EN 13445 "Unfired pressure vessels" Maintenance Help Desk (MHD) Question form

Request reference number (to be filled by MHD): (2014)-02-05		Date: 2017-03-24		
Please fulfil the following				
Part: EN 13445-2	Issue: 2014	Page 16	Subclause 5	National Standard Reference --
Subject: Materials used for non-pressure parts				
Type of request:				
<input checked="" type="checkbox"/> Technical clarification		<input type="checkbox"/> Editorial correction		
<input type="checkbox"/> Technical comment		<input type="checkbox"/> Translation correction		
From : Company: VSK Pardubice s.r.o. Name: Tereza Bílková Postal address: Stará Obec 312 533 54 Pardubice-Rybitví Czech Republic		e-mail: tereza.bilkova@vsk.cz phone: +420 732 418 194		
<input checked="" type="checkbox"/> Manufacturer	<input type="checkbox"/> User	<input type="checkbox"/> Other (please specify):

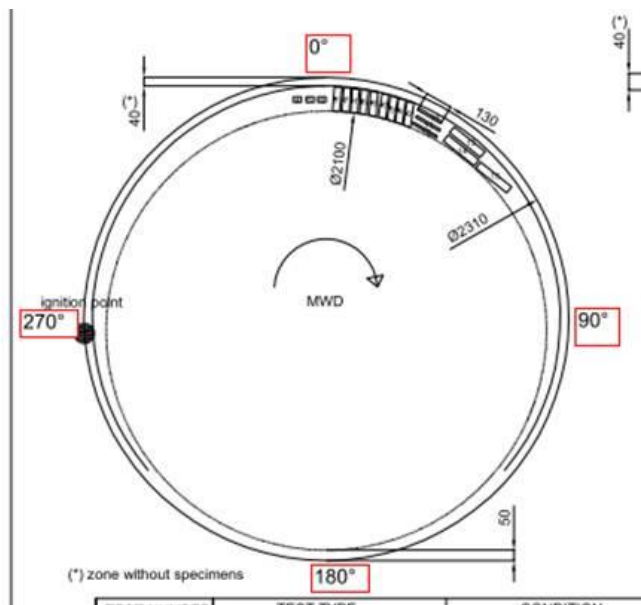
Dear Sir / Madam, we have a query regarding components that are to be explosive clad, to EN13445-2. The components are both Tubesheets, one in P245 GH Carbon Steel at $\varnothing 2.3\text{m} \times 80\text{mm}$ main section and the other in P265 GH at $\varnothing 2.1\text{m} \times 130\text{mm}$ main section, finished sizes. Both Tubesheets are to be clad in Titanium to B265, 10mm thick, with a finished thickness of 6mm.

The cladding operation is being completed by an external supplier. They are working to EN13445-2, Annex D, and our customer, EDF, spec BTS 91.C.109.UKEPR, Appendix 19. The EDF spec states the following 'When the cladding is carried out by explosion, the test specimens shall be taken in the zone furthest away from the ignition point'. In this instance, the ignition point would therefore be at 180° to the test piece location. This was originally mutually agreed by a procurement spec.

"In order to increase as much as possible the material for test specimens, the Tubeplate to be obtained has been moved on one side of starting forging (180°), leaving 50 mm in order to guarantee the adhesion of titanium plate after cladding on entire surface of Tubeplate.

At the same time the ignition point has been positioned at 270° (previously 180°) of starting forging, in order to increase the distance between ignition point and the Tubeplate, and respect as far as possible the BTS requirements about the placement of test specimens."

RR are looking to determine if this is an acceptable proposal.

- The effect of having the test pieces positioned furthest away from the ignition point, does this give better or worse case mechanical results?
- What effect (if any) is likely by following our supplier's proposal. Are we likely to see better or worse mechanical results?
- The effect of the test pieces positioned at the edge of the component. Are there any detrimental effects due to the shape of the component, and the location of the test pieces?

This is a specific technical specification to EDF.
Informative Annex D of EN 13445-2 has no recommendation on this matter
